**PERMIT REPORT**

Re: Permit 19-170: 4798/4800 Northern Road, Mound, MN 55364

Brad and Jennifer Totoritis-Searl (Applicant) have applied for a Minnehaha Creek Watershed District (MCWD) permit for single family home remodeling and construction. This project proposes demolishing one existing single family home and building an addition onto a second existing single family home, consolidating the two lots. The Applicant's stated purpose of the addition is to create an additional main floor living space for an elderly parent. The homes are located on the northwest portion of Lake Minnetonka, adjacent to Harrison's Bay, and majority of the site is within the 100-year floodplain. The application is before the MCWD Board of Managers for consideration as the Applicant has requested a Variance from full compliance with section 3(f) of the Floodplain Alteration rule. The application was complete on June 13th, 2019.

Attachment 3

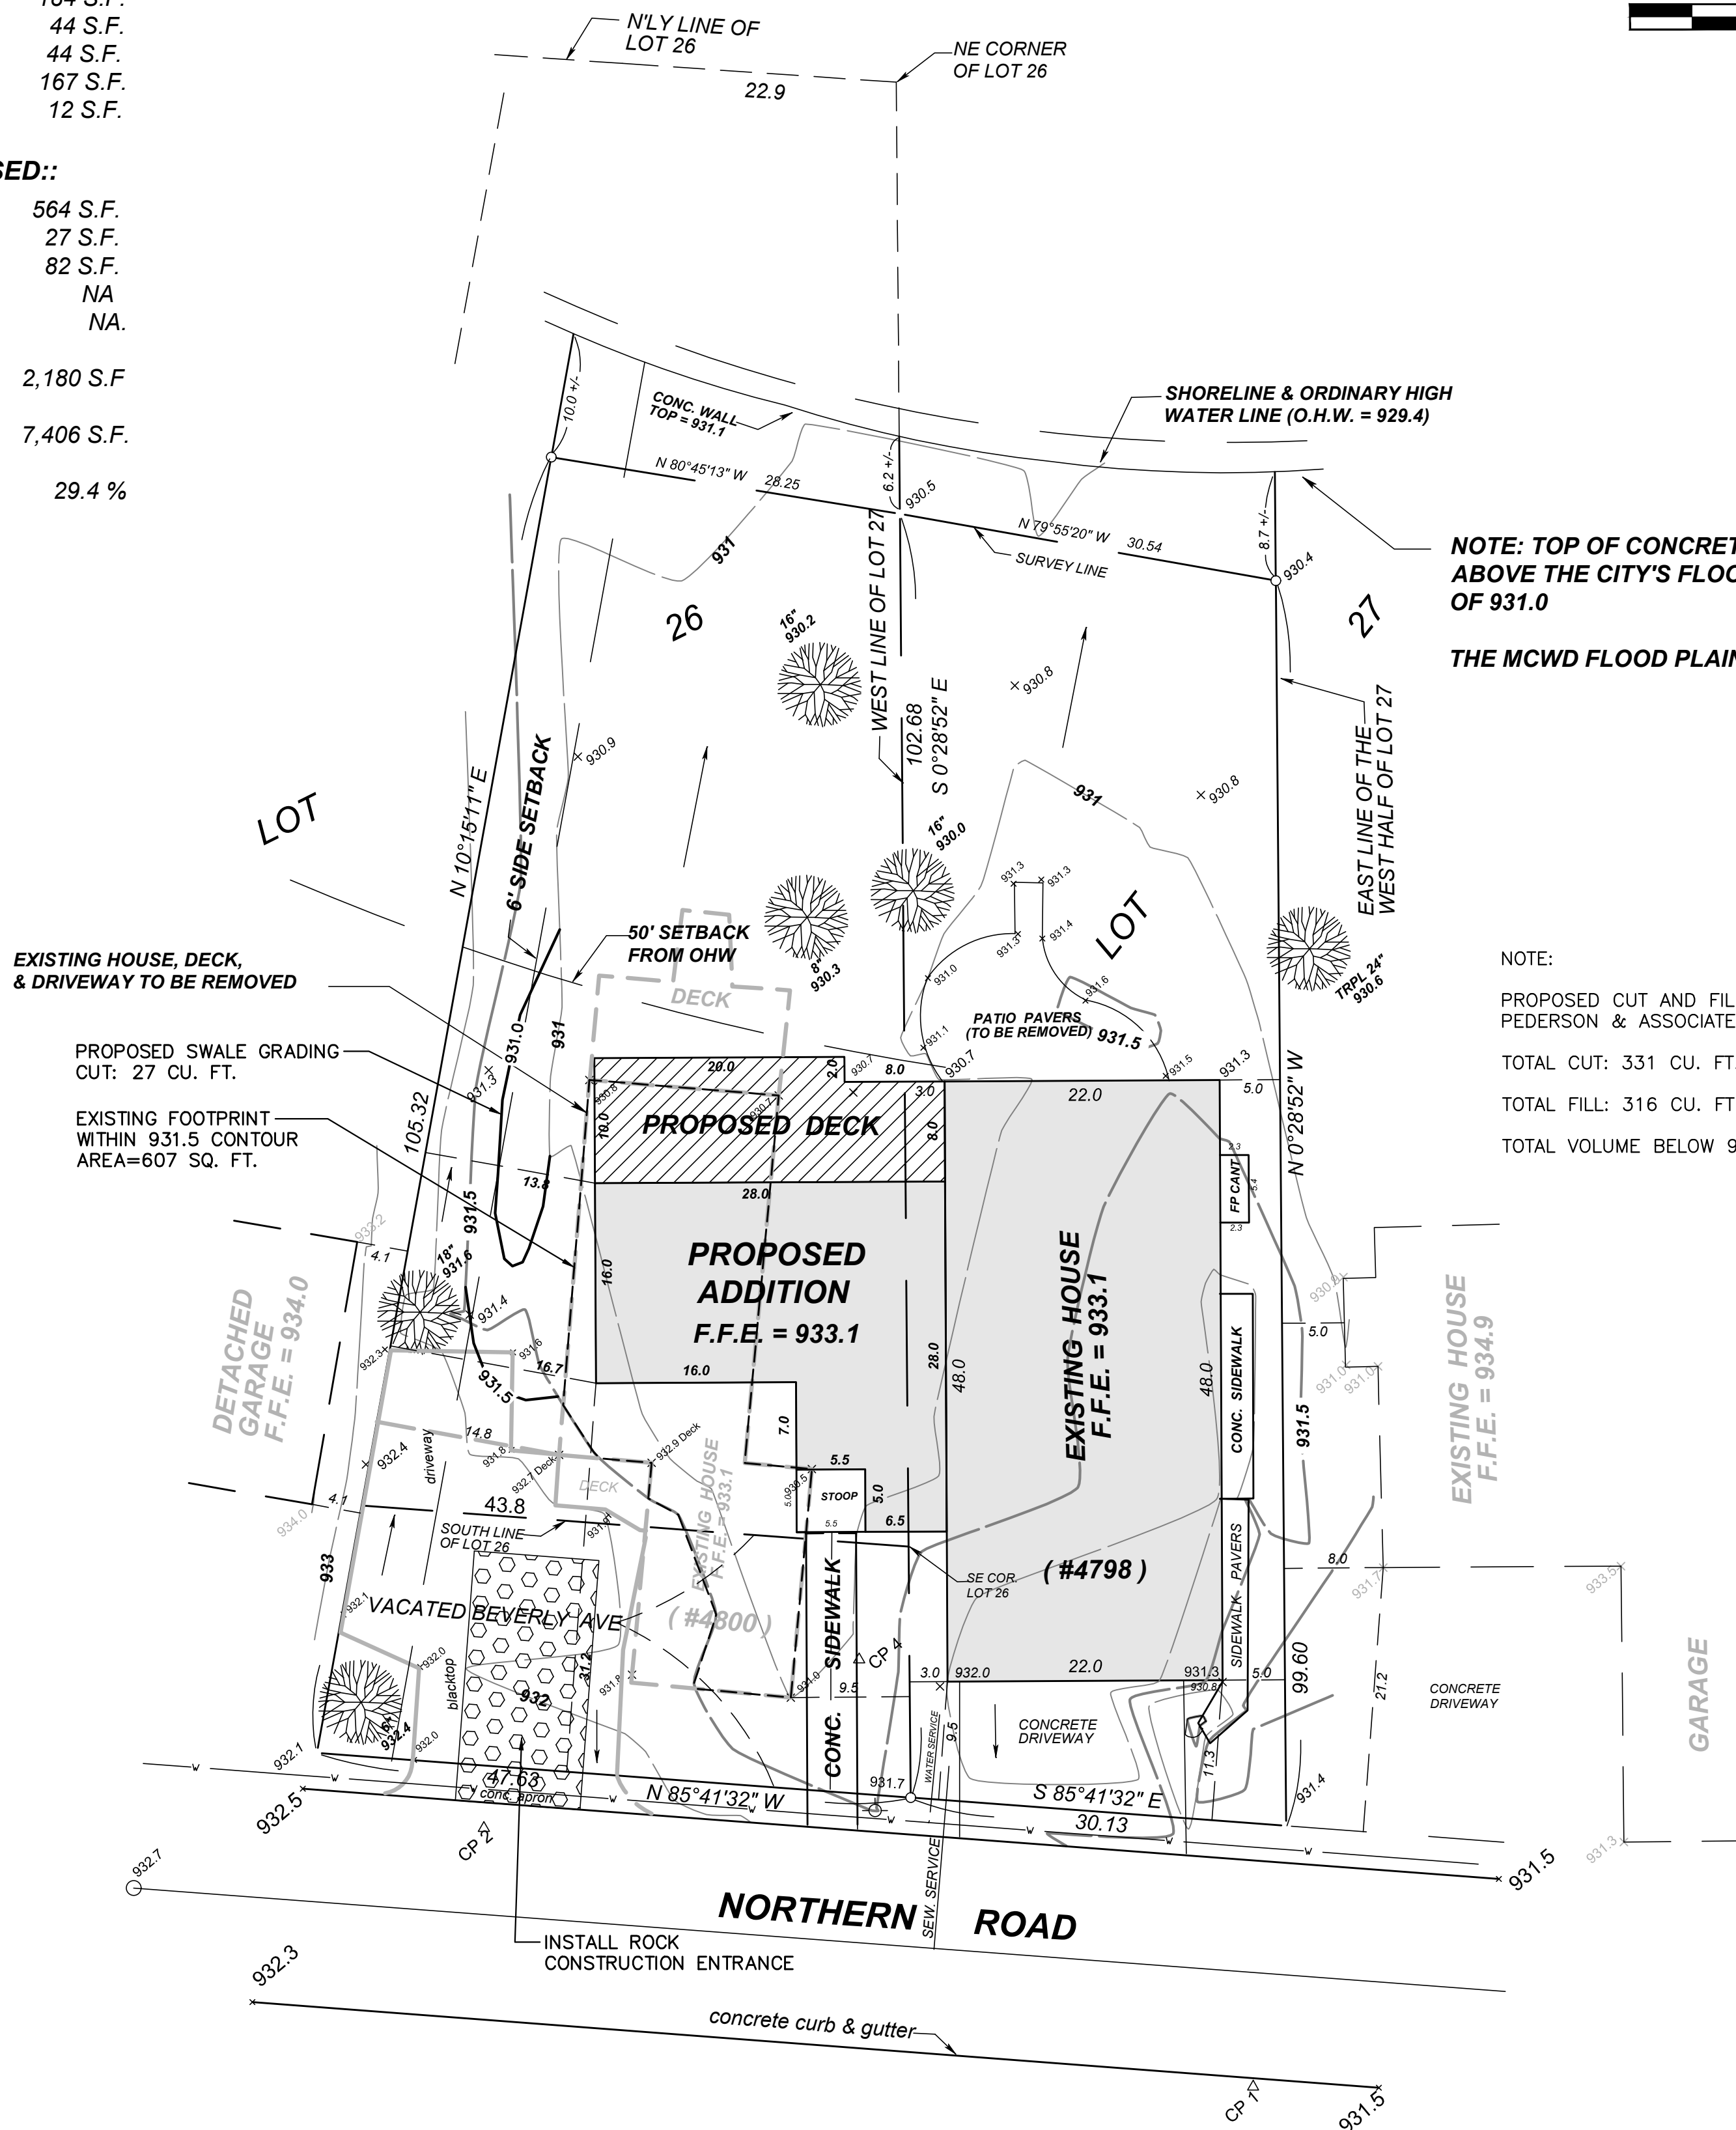
The District's Erosion Control Rule is applied to projects proposing 5,000 square feet of disturbance or 50 cubic yards of fill, excavation, or stockpiling on-site. The Applicant is proposing 800 square feet of disturbance and 120 cubic yards of excavation, therefore the rule is applied. In accordance with the rule provisions, the Applicant has submitted an erosion control plan which identifies erosion and sediment control best management practices. These include: silt fence down gradient of disturbed areas, a crushed-rock construction entrance, and a concrete washout area contained on the truck. Additionally, a final stabilization plan including sod and the incorporation of six-inches of topsoil into underlying soils and has been provided (attachment 3).

Per section 3(a) of the rule, fill shall not cause a net decrease in storage capacity below the projected 100-year HWL of a waterbody and any fill brought onsite below the projected 100-year HWL must be mitigated by the creation of compensatory storage. The Applicant has submitted plans and quantified calculations, computed and signed by a professional engineer, to demonstrate the project will result in 316 cubic feet of fill and 331 cubic feet of compensatory storage, for a net increase of 15 cubic feet of storage within the floodplain. The District Engineer has reviewed the plans and has confirmed that the project will result in a net increase of 15 cubic feet, 0.6 cubic yards, of new floodplain storage below the 931.5' elevation contour, therefore the criteria of section 3(a) has been met.

Section 3(f) of the rule requires that the low-entry openings to all residential, commercial, and institutional structures be a minimum of 2 feet above the 100 year high-water level. The proposed project does not meet section 3(f) and the Applicant is requesting a variance for providing 1.6' of freeboard between low-entry openings and the 100 year HWL for this component of the District's Floodplain Alteration Rule.

The analysis submitted by the applicant indicates that the elevation of the proposed addition will increase flood risk only for the applicant's proposed properties. The noncompliance with the MCWD low-opening elevation standard described above is the result of a decision by the applicant. MCWD legal counsel notes that if the managers elect to approve the variance based on the engineer's and staff's analysis finding no risk of flooding to adjacent properties, it would be prudent for the managers to require, as a condition of approval of the variance that the applicant add notation of the noncompliant low-floor condition for the relevant structures to the declaration recorded on the project property as a condition of approval. The managers may also consider whether to require the applicant to indemnify MCWD for flood damages resulting from the noncompliant opening.

- Reimbursement of fees for engineer and legal review
- Submission of draft declaration memorializing the noncompliant low-opening elevation for review by District Staff and then recordation
- That the Board of Managers consider if a submission of a draft indemnification of MCWD for flooding damages arising from noncompliant low-opening be a condition of approval.
